DA SUBMISSION CHANGES

18-24 RAILWAY ST LIDCOMBE

DEVELOPMENT APPLICATION

SHEET NO. **DA301** REVISION **D.**

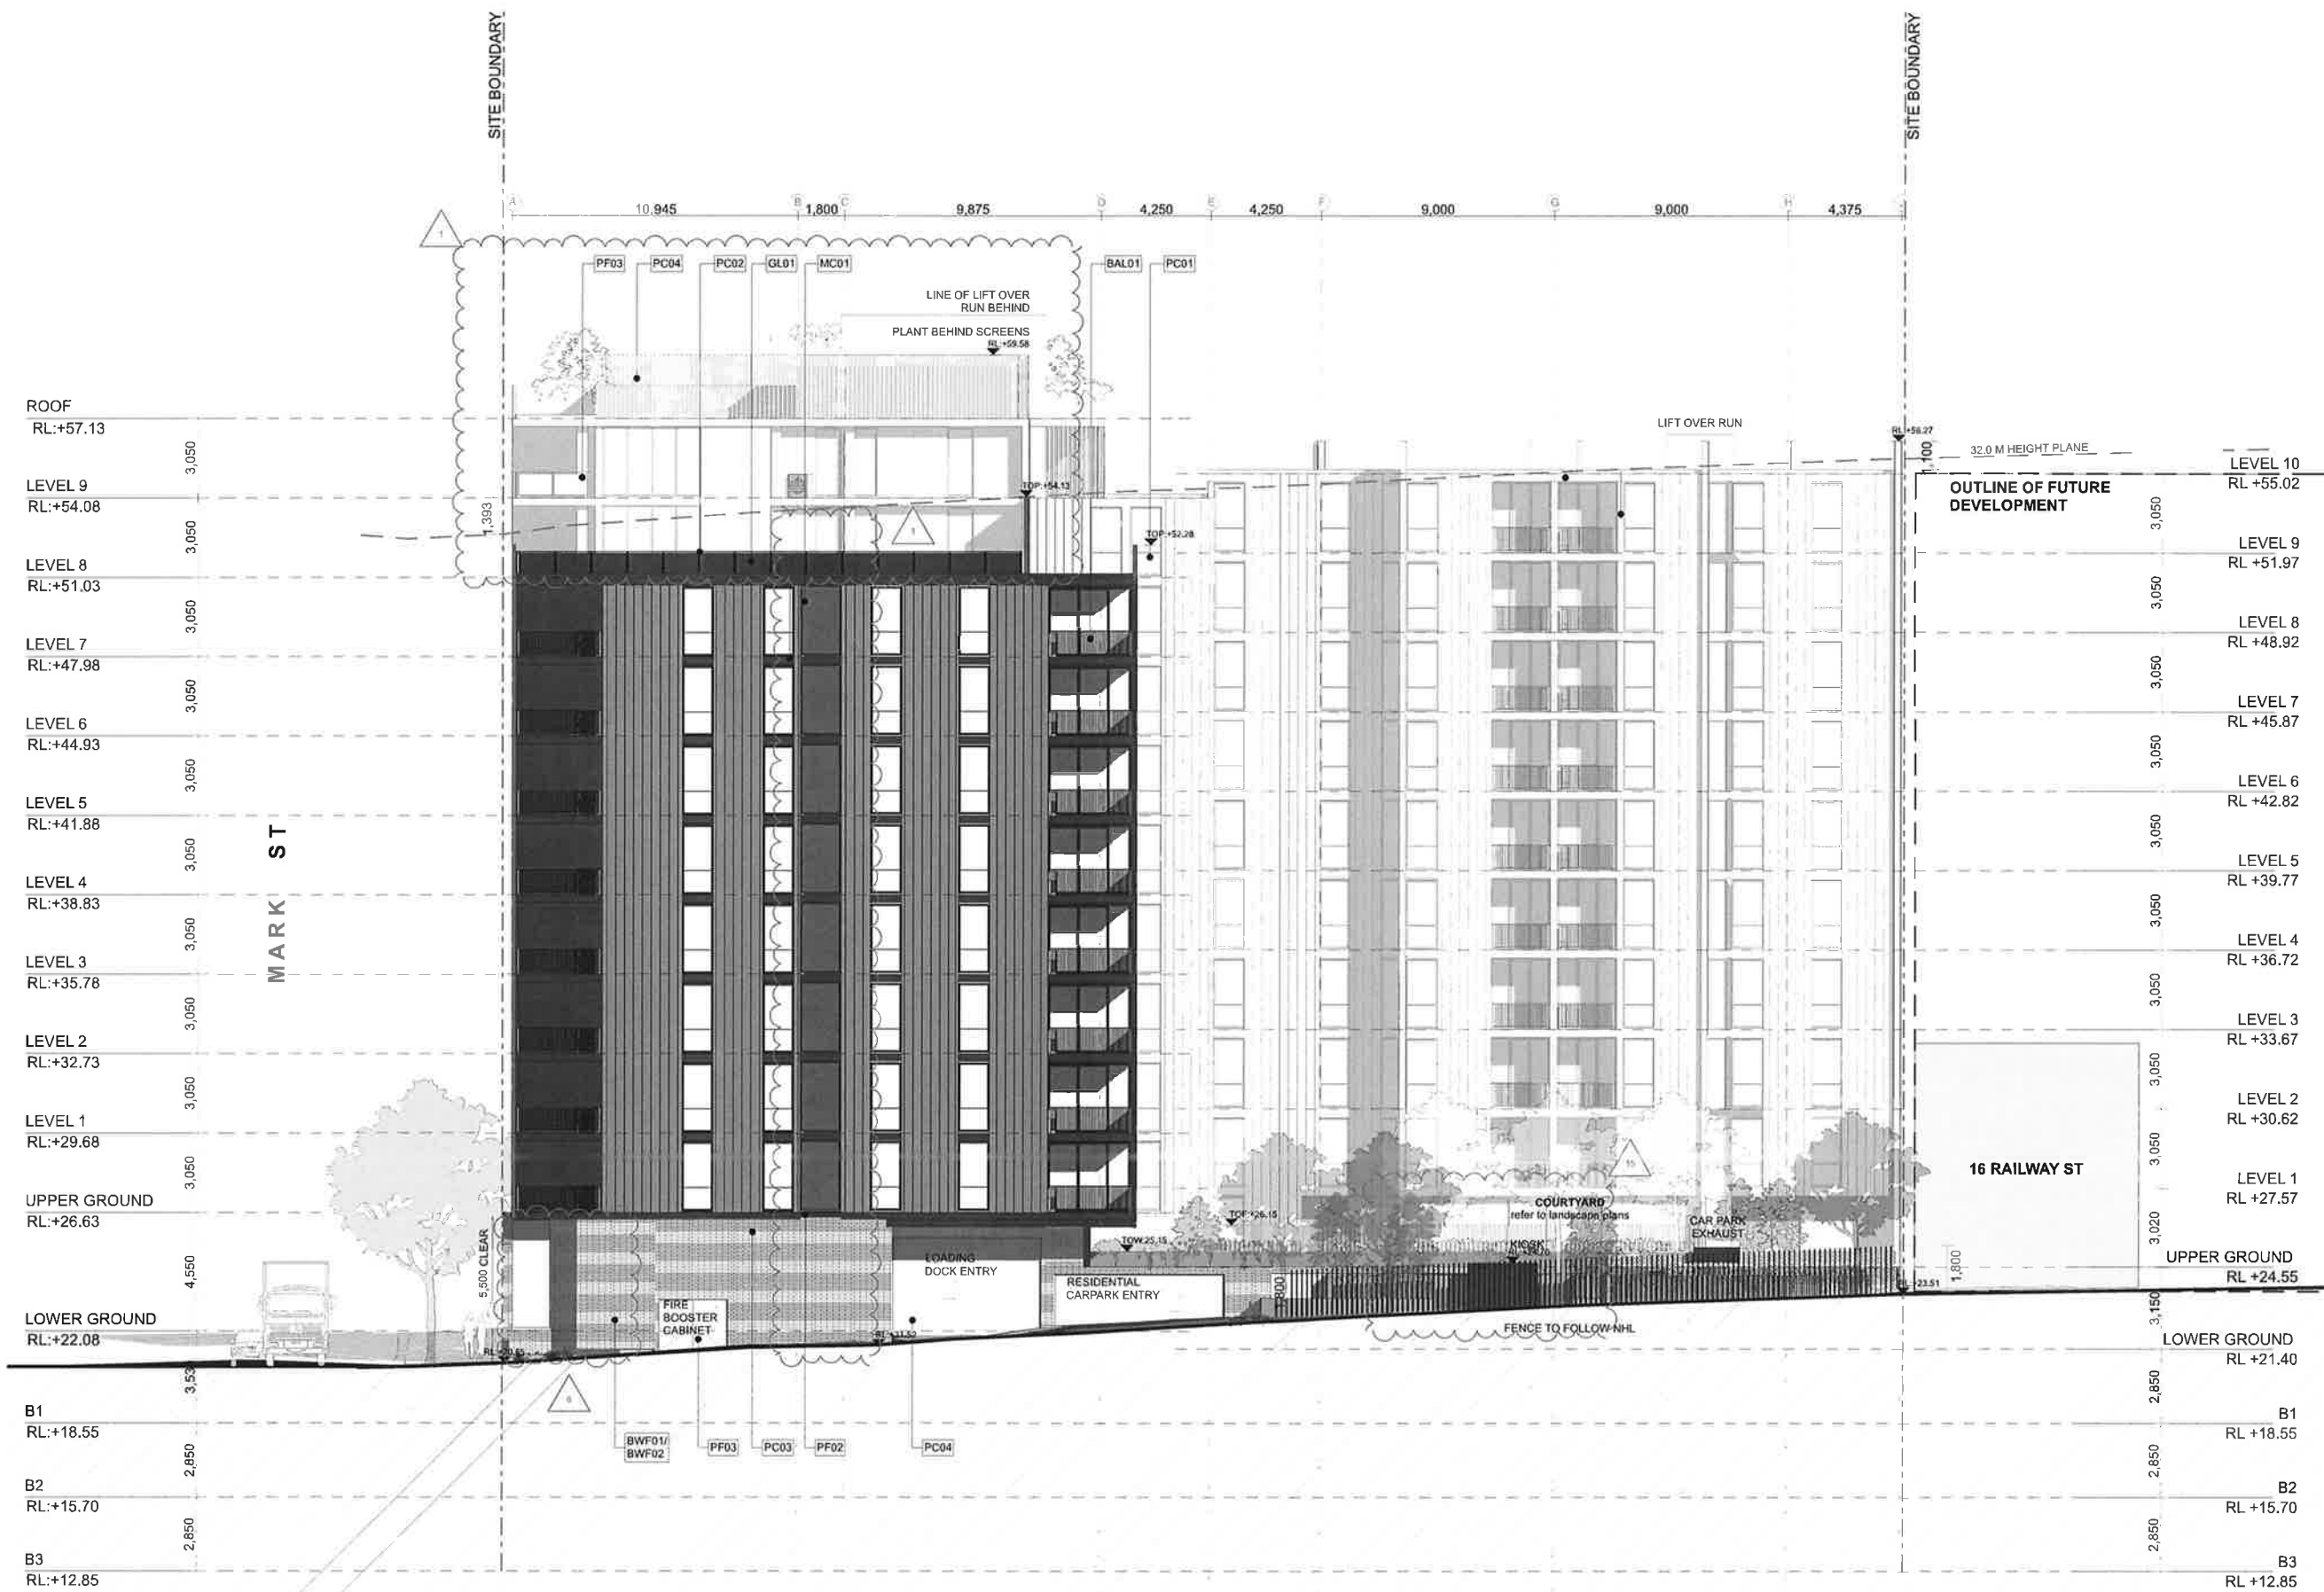
1. SOUTH FIRE STAIR DELETED.
2. BASEMENT 2 EXTENDED.
3. GROUND TANK RELOCATED TO BASEMENT 1, SPRINKLERS.
4. FIRE HYDRANT ROOM SHIFTED TOWARDS WEST.
5. RETAIL STORAGE ADDED ON LOWER GROUND LEVEL.

6. AT PREVIOUS GROUND TANK LOCATION.
7. VEHICLE ENTRY RAMP REPLACED WITH RETAIL.
8. LOWER GROUND UNITS REPLACED WITH RETAIL.
9. GROUND LEVEL.
10. WASTE HOLDING AREA RELOCATED.

11. MANAGER OFFICE ADDED ON LOWER GROUND.
12. LOWER GROUND LEVEL, TOILETS AMENDED.
13. SOUTH EAST UNIT REPLANNED TO ACHIEVE SOLAR ACCESS.
14. WEST CORNER TO HOST A SET OF SCREEN STAIRS, TRAVELING DISTANCE FROM STAIRS TO SOUTH UNITS REDUCED TO 4 METRES.

PROJECT
18-24 RAILWAY ST LIDCOMBE
SITE ADDRESS
18-24 Railway Street Lidcombe
JOB NO:
1604
CHECKED: [signature] DRAWN:
DATE: 11.05.2016 SCALE: 1:20 @A1 A3@50%
PROJECT STATUS
DEVELOPMENT APPLICATION
DRAWING TITLE
SECTION C
SHEET NO. REVISION:
DA303 A

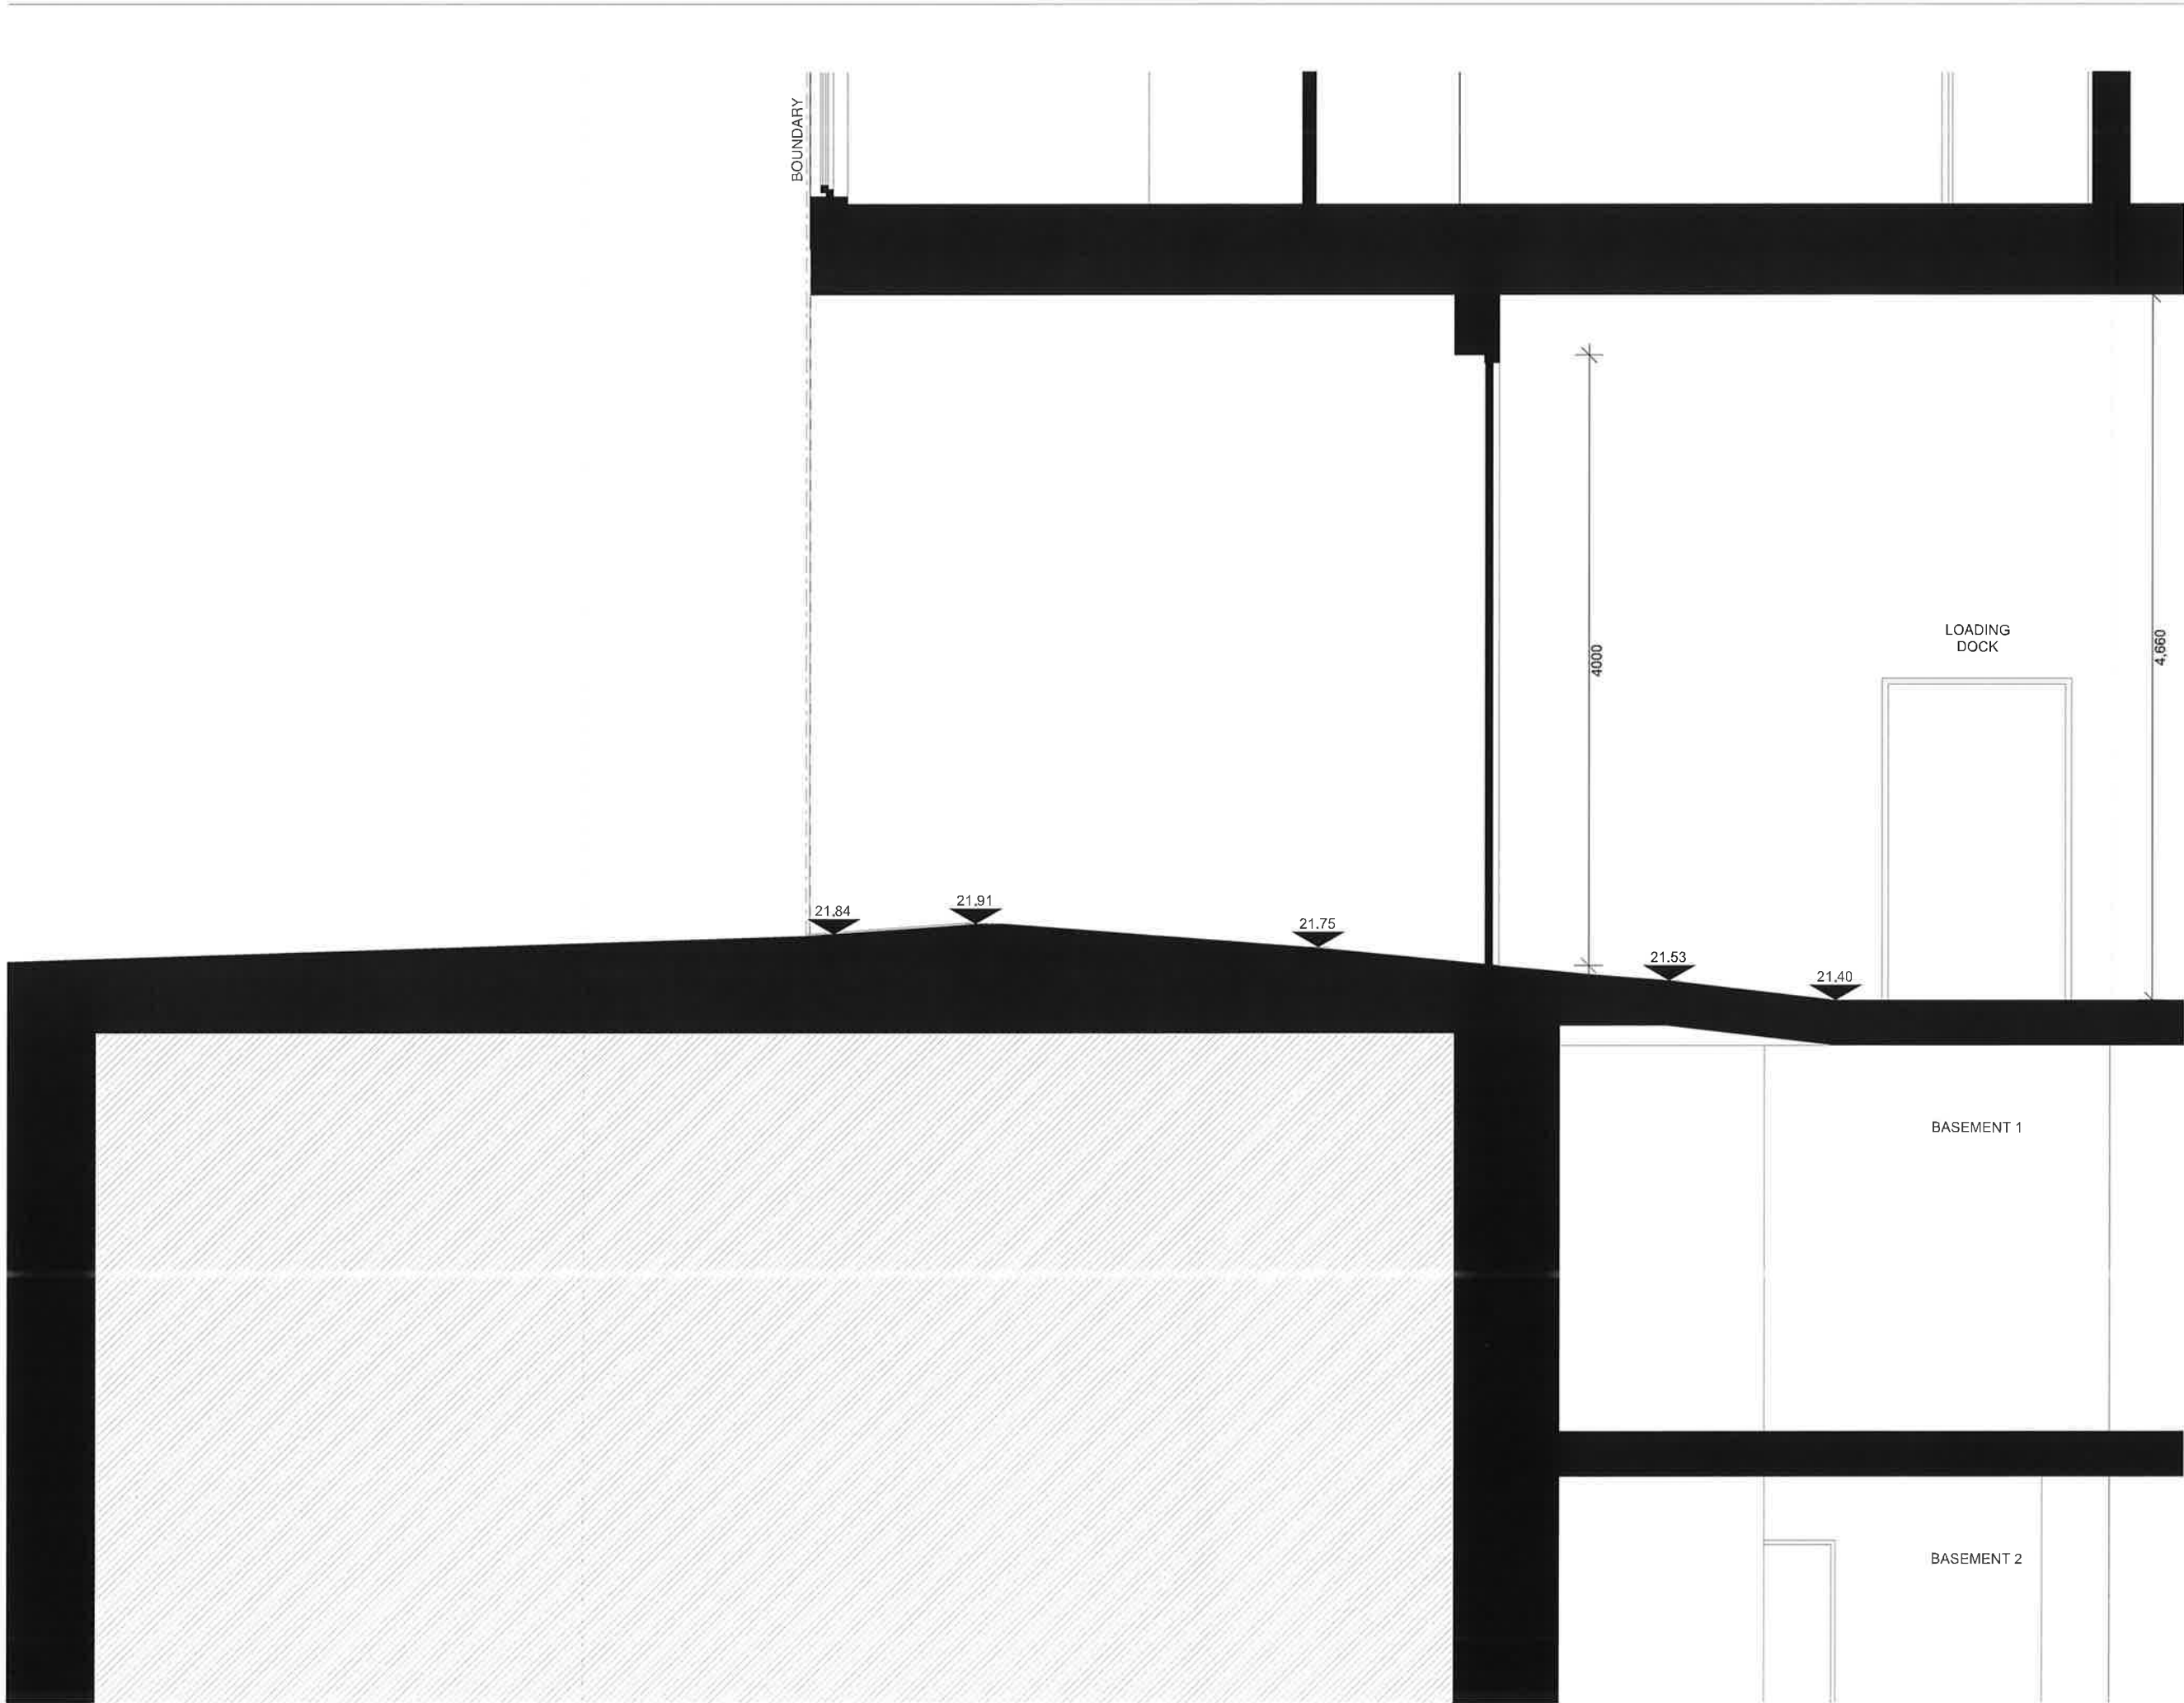
- DA SUBMISSION CHANGES:
- 1- SOUTH FIRE SIGN DELETED.
 - 2- BASEMENT 2 EXTENDED.
 - 3- GAS TANK RELOCATED TO BASEMENT 1, SPRINKLERS
 - 4- FIRE MUGRANT ROOM SHIFTED TOWARDS WELL

- 5- RETAIL STORAGE ADDED ON LOWER GROUND LEVEL
 - 6- PREVIOUS GAS TANK LOCATION
 - 7- MOTOR VEHICLE ENTRY RAMP RLS UPDATED.
 - 8- LOWER GROUND UNITS REPLACED WITH RETAIL SPACES

- 9- WASTE HOLDING AREA RELOCATED.
 - 10- MANAGER OFFICE ADDED ON LOWER GROUND LEVEL.
 - 11- LOWER GROUND LEVEL TOILETS AMENDED.
 - 12- SOUTH EAST UNIT REPLANNED TO ACHIEVE SOLAR ACCESS.

- 13- WEST CORNER TO HOST A SET OF SCISSOR STAIRS, TRAVELLING DISTANCE FROM STAIRS TO SOUTH UNITS REDUCED TO 10 METRES.
 - 14- PEDESTRIAN ENTRY RAMP AMENDED.

- 15- THREE BEDROOM UNIT REPLANNED.
 - 16- BRICKWORK ON INTERNAL EAST ELEVATION ADDED.
 - 17- AMENDMENTS TO KITCHEN.
 - 18- 2X2BED UNITS REPLACED WITH 2X1BED UNITS.

- 19- 1X3BED UNIT REPLACED WITH 2X1BED UNITS
 - 20- SCREENS DELETED
